**From:** Paddy McDonald <padriff@hotmail.com>  
**Sent:** Wednesday, September 13, 2017 4:16 PM  
**To:** PRC  
**Subject:** Project #3020338, 2925 E Madison St.

Dear Magda and Design Review Board,

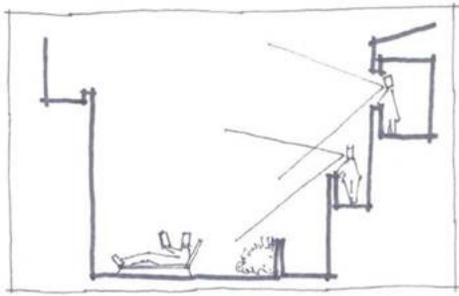
To illustrate some of these points, consider this illustration from the Design Review Guidelines CS2-D on page 6:

Inappropriate siting of large buildings can reduce the privacy of adjacent homes. Reducing windows and decks overlooking neighboring residential property or increasing side setbacks can increase privacy.

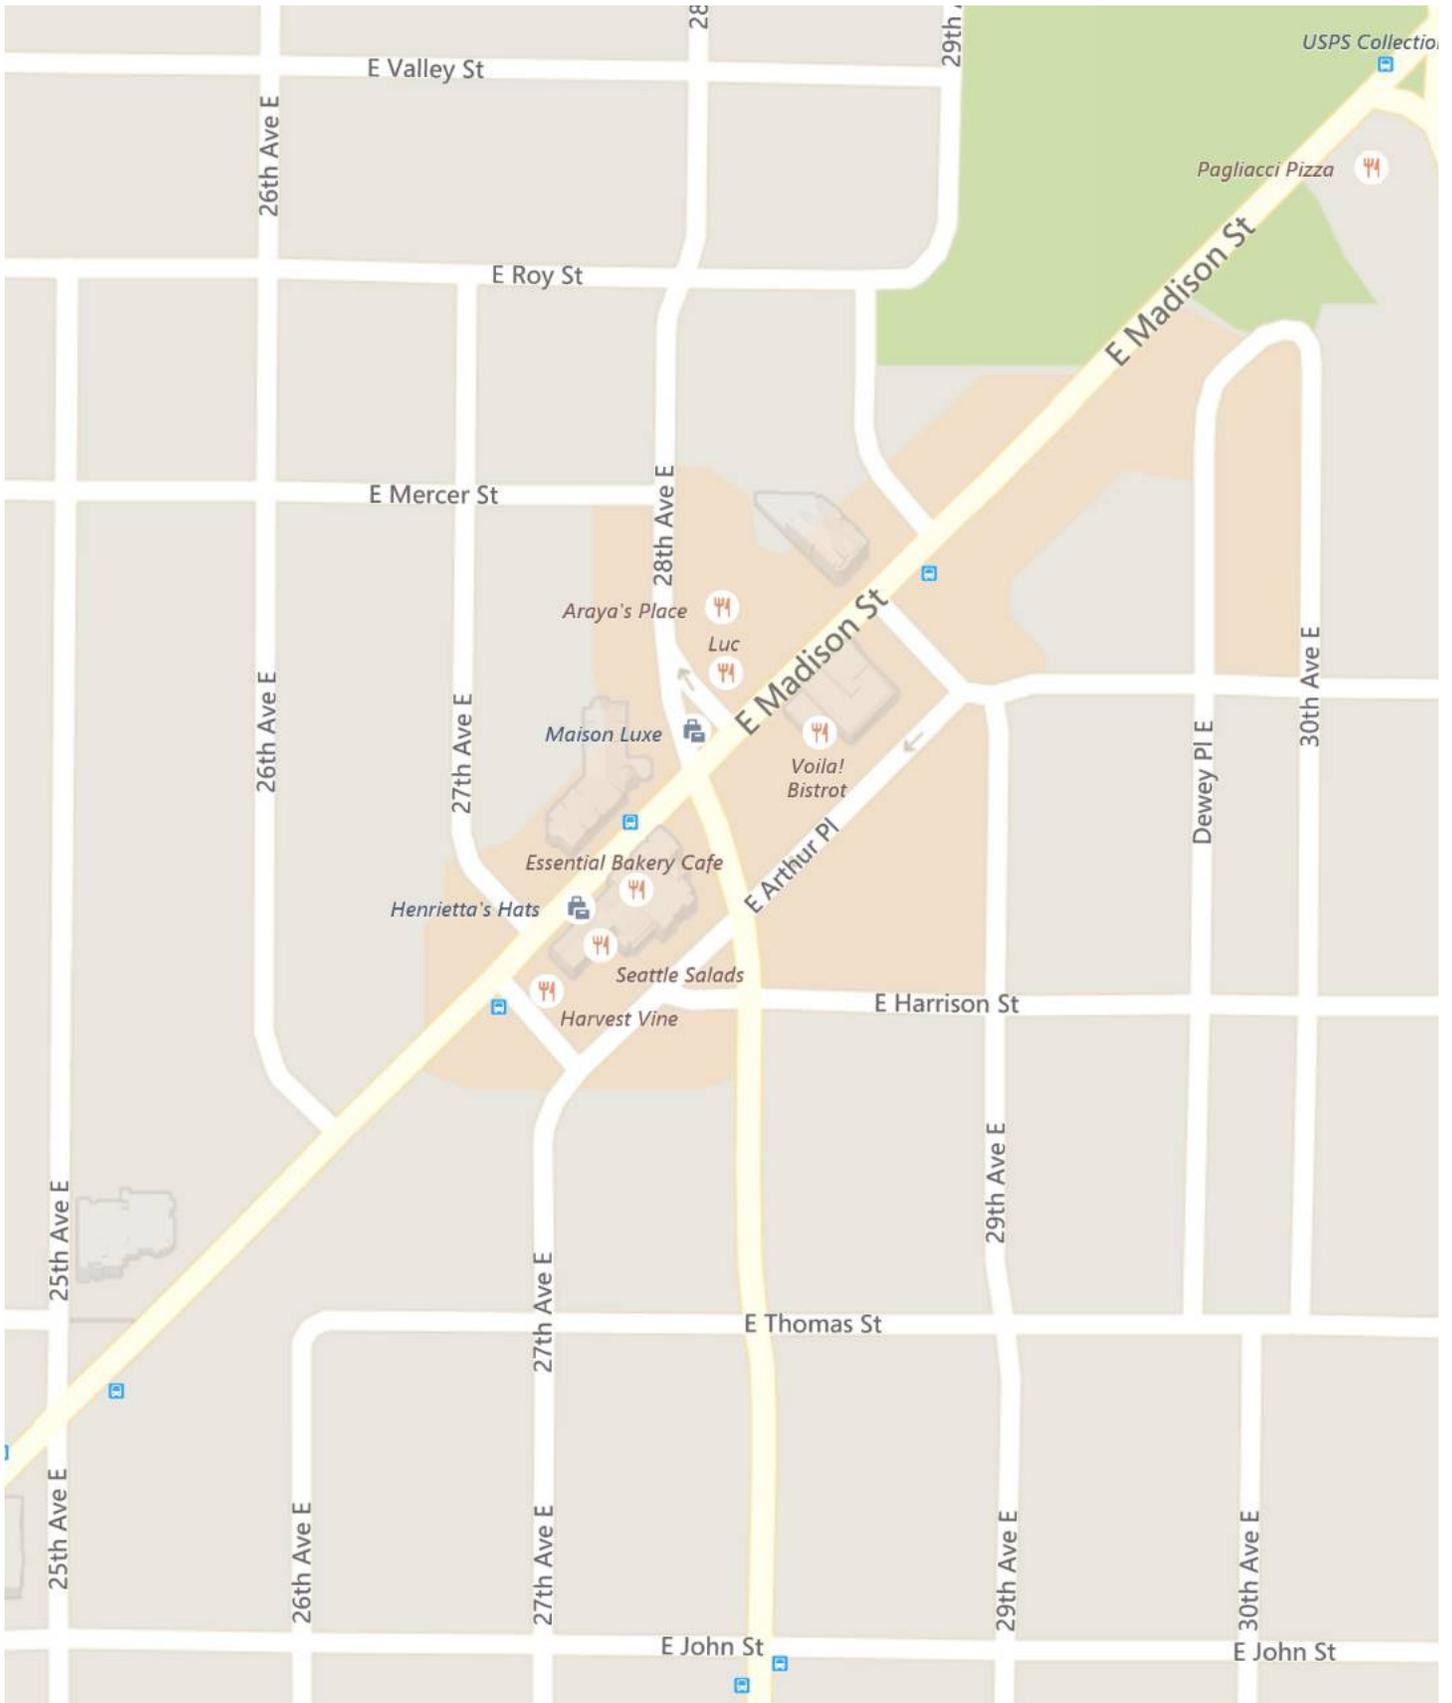
Then consider the following photographs take on the scale model constructed by Save Madison Valley from the indicated positions of windows and balconies on the floors above the retail space. It is exceptionally clear to me that this kind of intrusion into the privacy of the neighboring single family homes is exactly the type of thing that is referred to as “Inappropriate siting of large buildings”
